SUBJECT: 2012 WATER IMPROVEMENT PROJECT

At Various Locations

ADDENDUM NO. 1

22 4" BLOW-OFF ASSEMBLY (NOT TO SCALE)

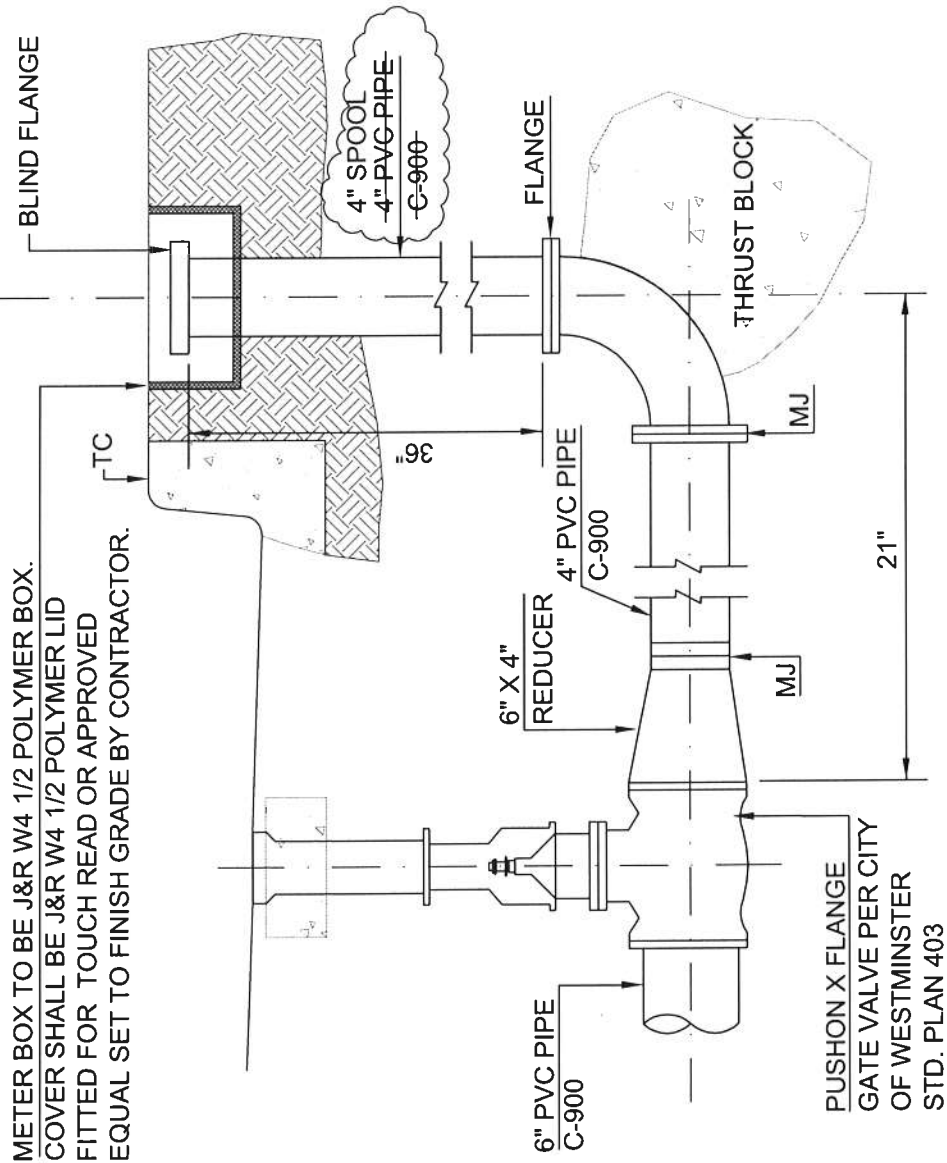
1. **Replace** "4-inch PVC Pipe C900" with "4-inch Spool" on Detail No. 22 4-inch Blow-off Assembly, shown on improvement plan sheet 1 of 4. See attachment.
2. **Add** "All water valves within the project limits shall be exposed at the end of the working day." after the first paragraph of Item 5, shown on page ASP-6 in the Specifications.
3. **Add** "The removed asbestos cement pipes shall be bagged and tapped at each end and delivered to the address above" after the first paragraph on page ASP-13 in the Specifications.
